Subject: Technical Review of “*Techno-Economics of Low-Carbon Freight Rail Transportation in California*”

Company: Benchmark Data & Control

Company: BNSF

Figure 1. Efficiency curve of Caterpillar C175-16, representative of medium speed diesel engines[3].

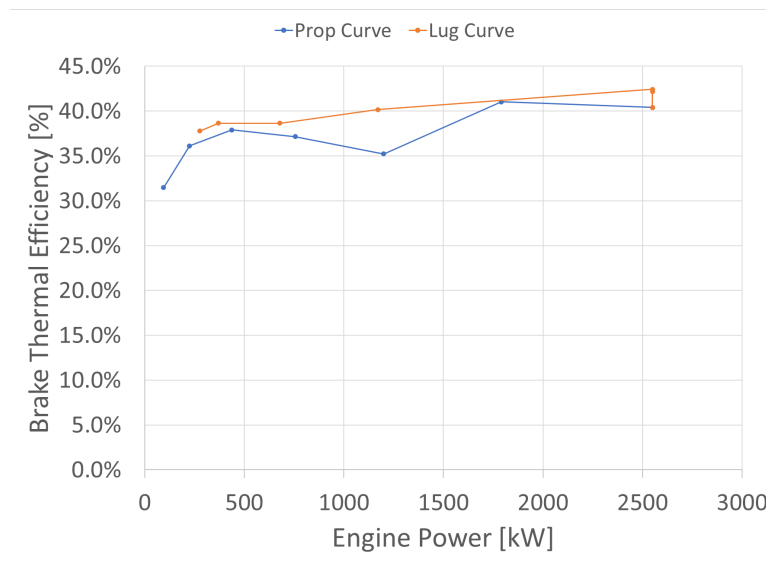
Gopinathan’s assumed diesel engine efficiency of 22.5%. This estimate was very low for a diesel engine that operates at a moderate load or higher. The data presented in Figure 1 is the efficiency curve for a Caterpillar C175-16 medium speed diesel engine and is about 40 percent [3]. The efficiency curve for the Wabtec Tier IV engine used by BNSF is not public information, but the C175-16 performance data is representative for engines of this class. Although Gopinathan references Popovich, et. al., Popovich estimates an average efficiency of

39% for this class her study[4]. The Popovich efficiency aligns with the C175-16 data. Thus, Gopinathan's assumed efficiency was about half this value which means his analysis doubles fuel consumption without any support.

The underestimation of diesel engine efficiency invalidates Gopinathan's later financial calculations. This assumption doubles the required amount of diesel fuel. This underestimation results an artificial and unsupported financial advantage for rail electrification and hydrogen.

Figure 2. Scatter plot of train tonnage and length for trains operating between the POLA and Barstow, CA with gross tonnages for Gopinathan, CARB, and Connolly denoted[1], [2], [5].

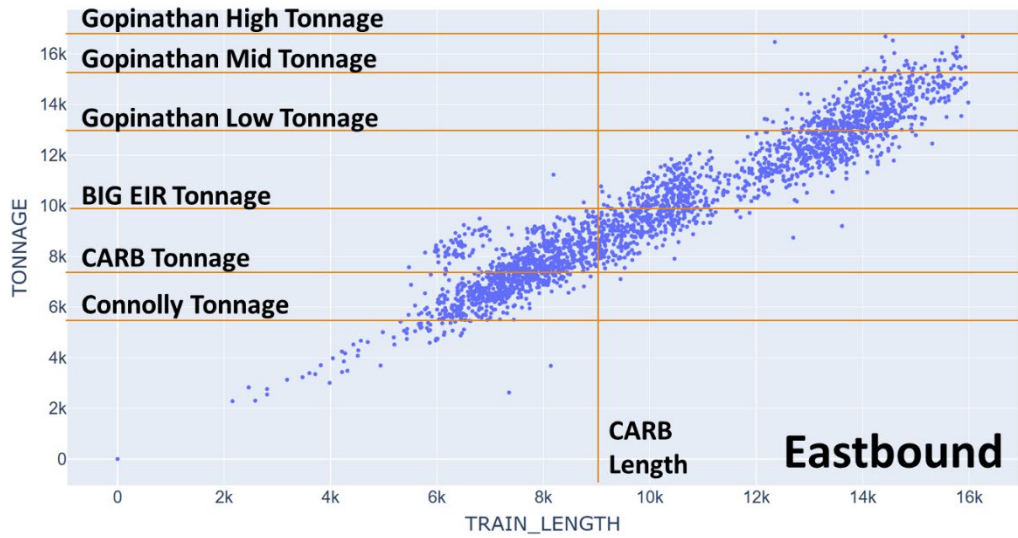
Gopinathan assumed an extremely heavy loaded car tonnage of 137.25 short tons. He then assumed train lengths based on the number of cars. These car counts ranged from 90 to 120. He did not estimate train lengths in feet or meters. Gopinathan's train tonnages are annotated in Figures 2 and 3 along with tonnages from the CARB and Connolly memos[1], [2], [5]. It would take 280 cars defined in the CARB Memo to match Gopinathan's 105 car, mid -level train, which roughly matches the BNSF train tonnage and length correlation as shown in Figures 2 and 3. These annotations demonstrate that Gopinathan's trains are not representative of actual BNSF trains.

These discrepancies in train definition are important because heavier cars require lower car counts to reach a specified tonnage. A train with fewer cars will have less rolling resistance and reduced aerodynamic drag when compared to trains with more cars and equivalent tonnage. Incorrectly estimating these loads results in an inaccurate energy requirement used for Gopinathan financial estimates.
